1/18/2023 | 6:00 PM

**MUNICIPAL SERVICES CENTER, COUNCIL CHAMBER
3600 TREMONT ROAD**

- a. Review of the November 16, 2022 BZAP minutes and January 4, 2023 BZAP Work Session minutes.
- b. 4462 Summit Ridge Drive (VAR-01-23) - To allow a front porch and addition to encroach up to 17.5 feet into the minimum 60-foot setback (unplatted) and to allow a side addition to encroach up to 13 feet into the 20-foot minimum setback.
- c. 3259 Kenyon Drive (VAR-03-23) - To allow a one-story addition to encroach 2'-6" into the 8-foot minimum side yard setback.
- d. 2797 Wellesley Drive (VAR-04-23) - To allow the construction of an attached pergola that encroaches up to 11'-3" into the minimum 33'-8" rear yard setback.

Figure 3 – Comparator unplatted lots along Lane Road

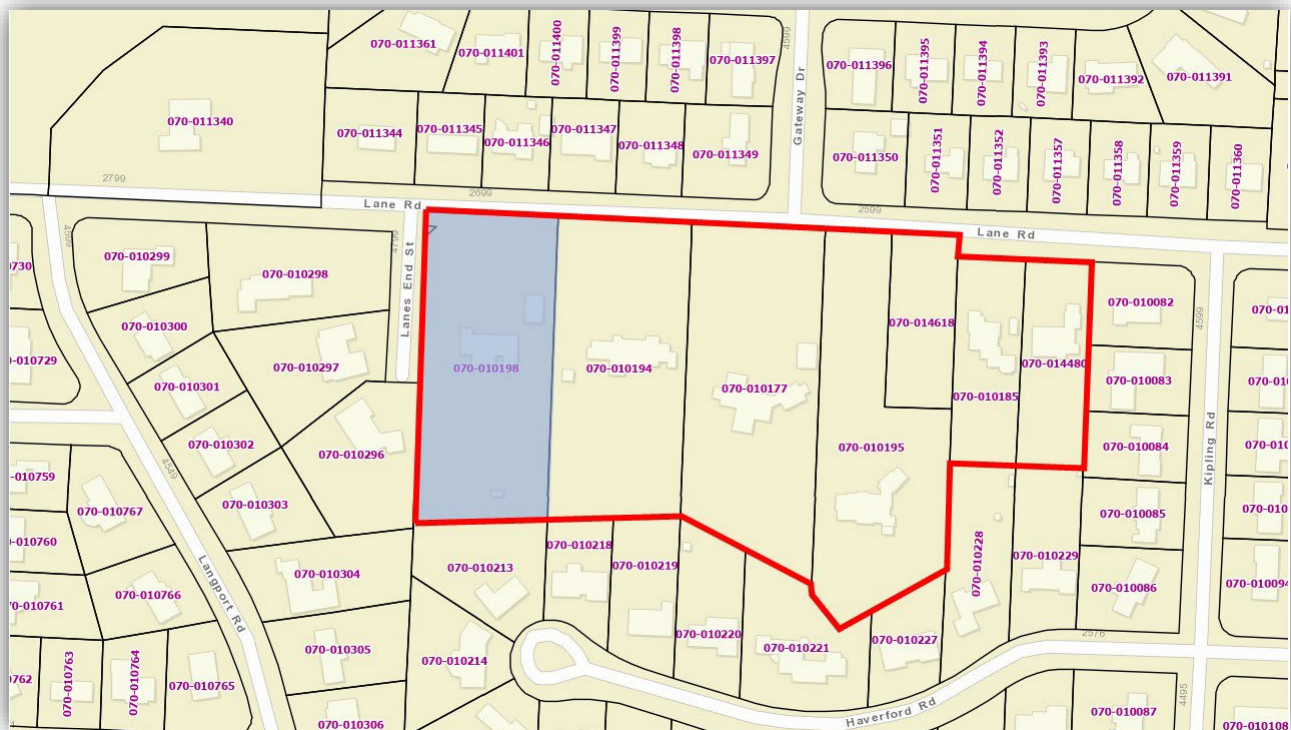
Along the south side of Lane Road, between Lanes End Street on the west and Kipling Road on the east, there are seven (7) unplatted properties (including the subject site), three with widths of 200 feet and four with widths of 100 feet, for an average width of 143 feet. These same seven unplatted properties range in size from 2.22 acres to 0.6-acre, with an average area of 1.47 acres (*see Table 1 and Figure 3*). **The two proposed lots that front on Lane Road each have 100 feet of frontage, well below the average for this part of Lane Road; the two proposed lots fronting on Lane Road are 0.406-acre and 0.599-acre, also well below the average size for the immediate area.** The unplatted lots abut several platted neighborhoods, each with their own established characteristics.

Lots located to the north, across Lane Road ([Wellington Woods; smaller, rectangular lots](#)), to the west ([Shelbourne Heights Extension, east-west oriented lots](#)); to the east at Kipling Road ([Kipling Forest, smaller, rectangular lots](#)) and to the south ([Kipling Forest Extension](#)) are all platted and therefore are not direct comparators. A mirroring of the Shelbourne Heights Extension opposite Lanes End Street was not considered as comparable because of its location, but may be a secondary factor to consider.

Figure 4: Proposed three-lot layout

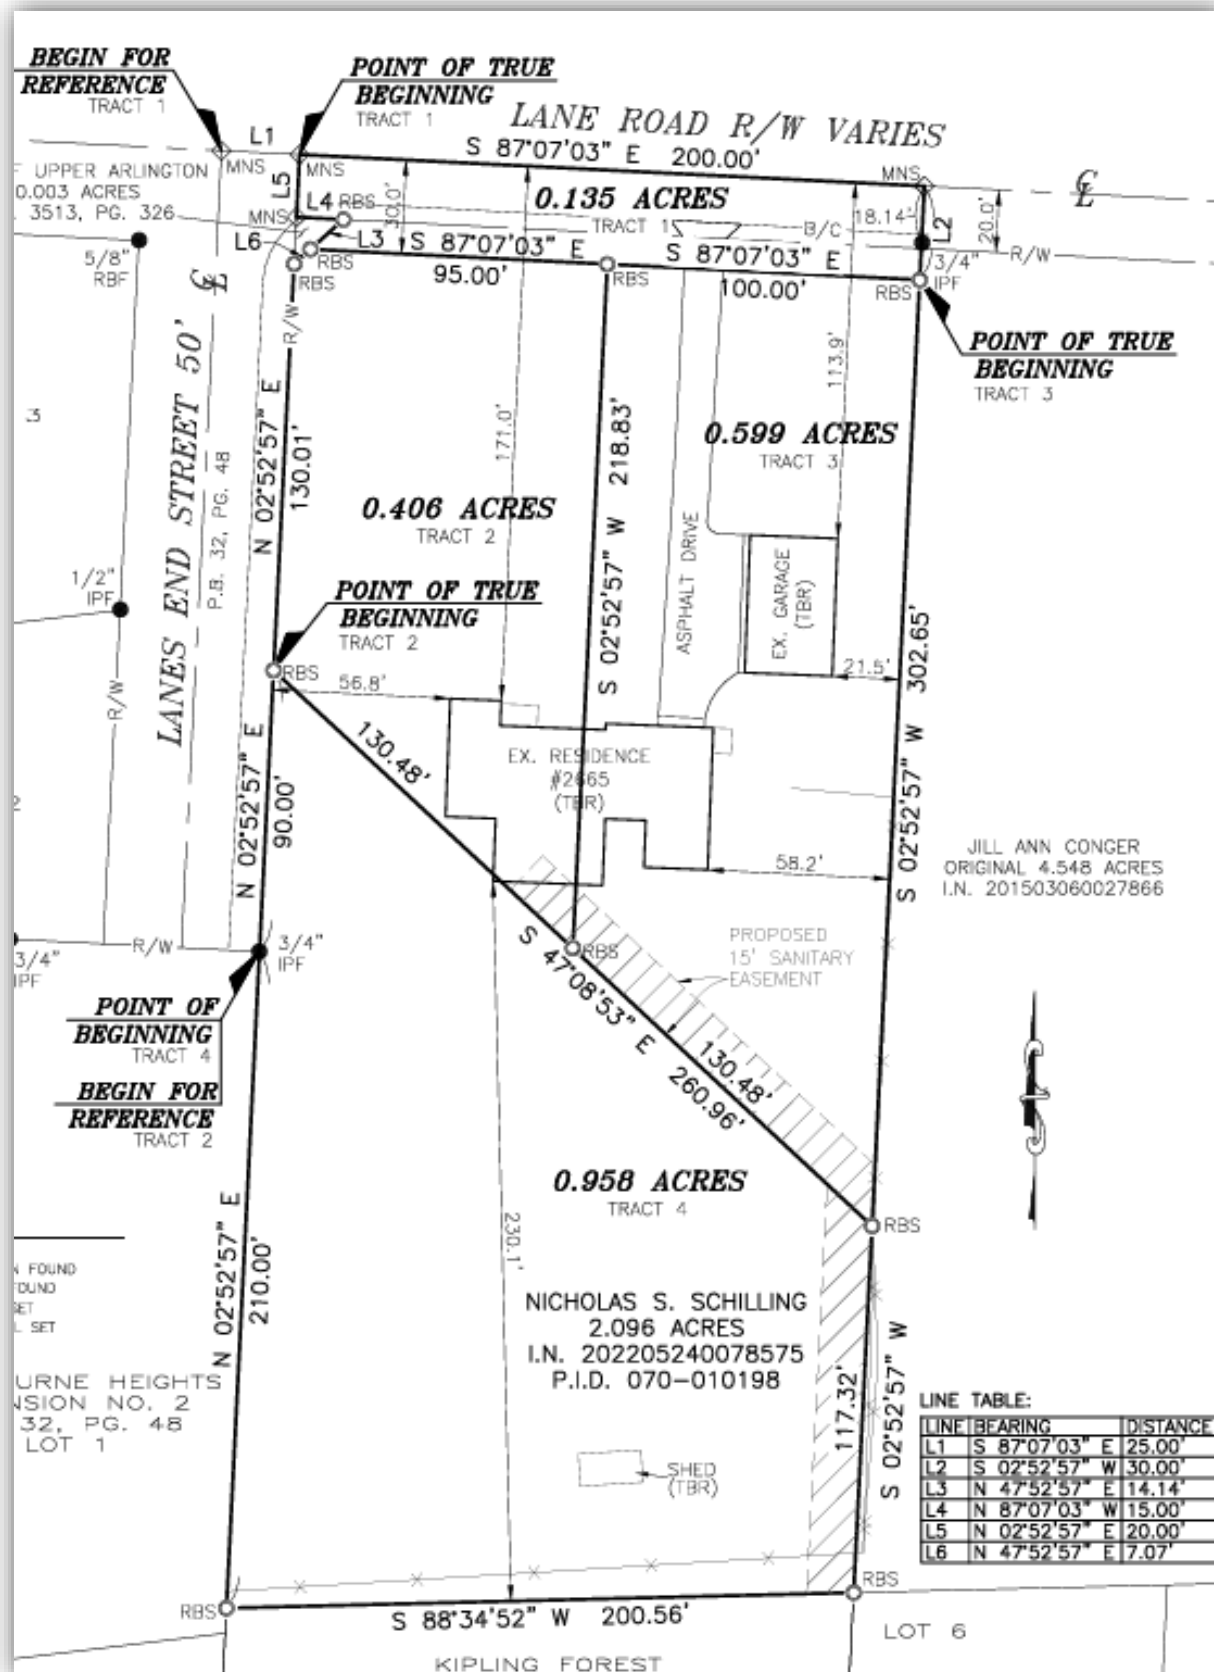
Concerns have been raised regarding stormwater runoff from the proposed project. The City Engineer has been to the subject property, and City staff regularly checks the existing downstream stormwater catch basin and clears debris if needed. For new homes and large additions, grading and drainage details are reviewed as part of the permit process, and must meet all minimum standards. Such standards ensure that runoff generated by new development does not create or exacerbate overland drainage issues. Roof gutters and downspouts must all be tied directly to the established stormwater management infrastructure or otherwise meet City Code. Construction which disturbs over one acre can be subject to both quantity and/or quality mitigation per the Ohio EPA. Should this project move forward, the Engineering and Building Divisions will collaborate to ensure compliance throughout the permit and inspection processes.
